**Technical Service
Information Bulletin**

INSTRUMENT PANEL RATTLE NOISE

'07 – '08 LS 460/460L & '08 LS 600h

NVH
NV011-07

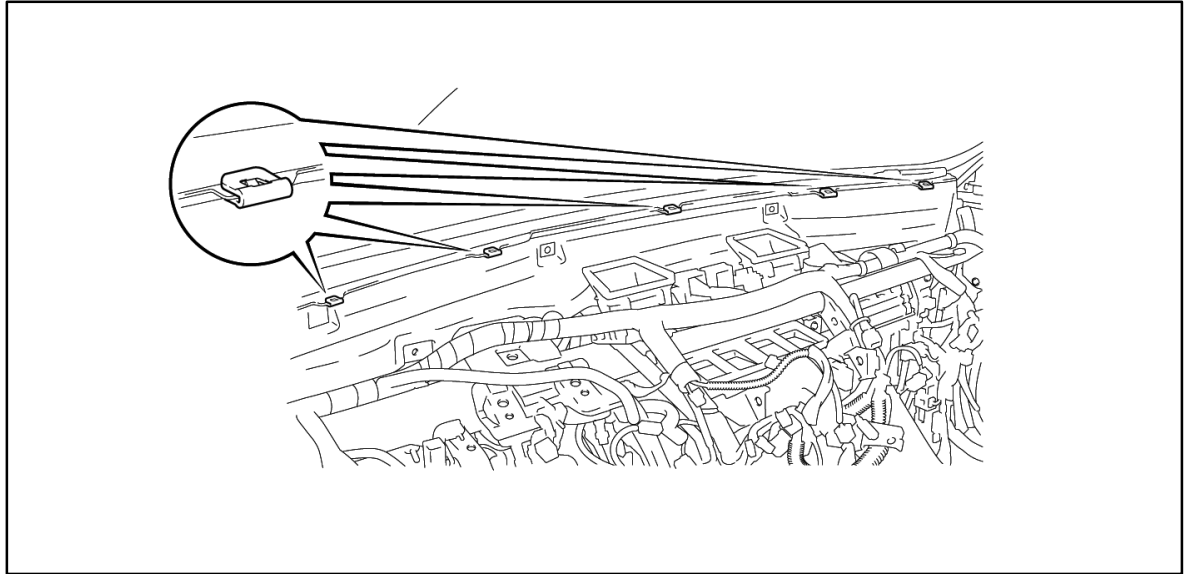
3. Install the 5 NEW clips to the cowl panel flange.

NOTE:

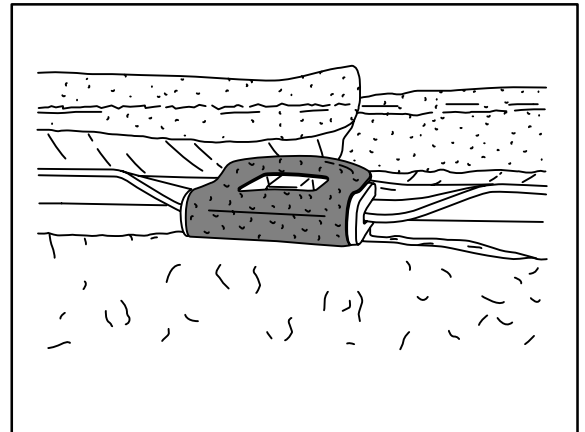
- The main difference for the NEW clips is the thicker felt.
- Install the clip so that the hole with the tab is visible at the TOP.
